Product Update

#06-0615

Product: EZ3500

Subject: EZ3500 using both EZ Feed Software and Trioliet Shiftronic mixer.

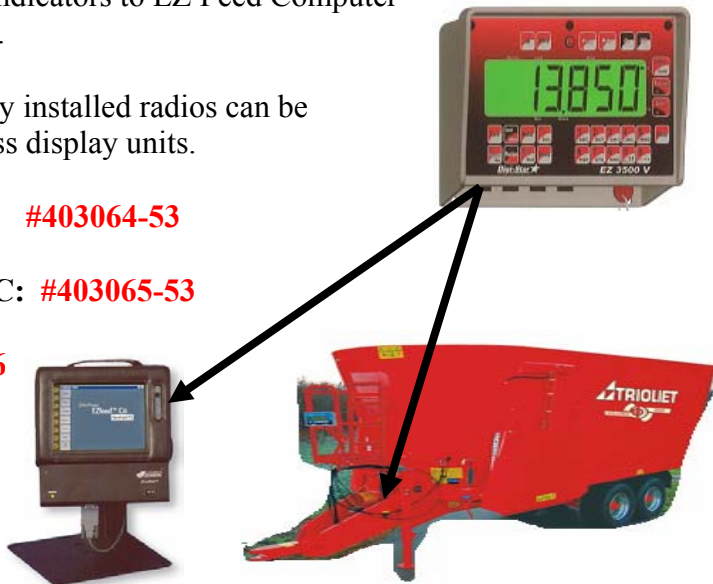
Both EZ Feed & Trioliet use the serial output of the Digi-Star indicator to update their system with weight information. In order for both systems to share this information Digi-Star has updated the serial port on the EZ3500 so that both can be connected with a Y cable.

- ★ New J904 serial port provides transmit ports to EZ Feed Computer and Trioliet Shiftronic mixers.
- ★ Y cable connects EZ3500/V indicators to EZ Feed Computer and Trioliet Shiftronic mixers.
- ★ EZ3500/V models with factory installed radios can be used with Cab Control wireless display units.

Set the indicator "SCOREBOARD MODE" (D.A.N. 213). Short Form Entry to "11" and install the new Y cable. Make sure that your indicator software version is EZ2 4.D or newer.
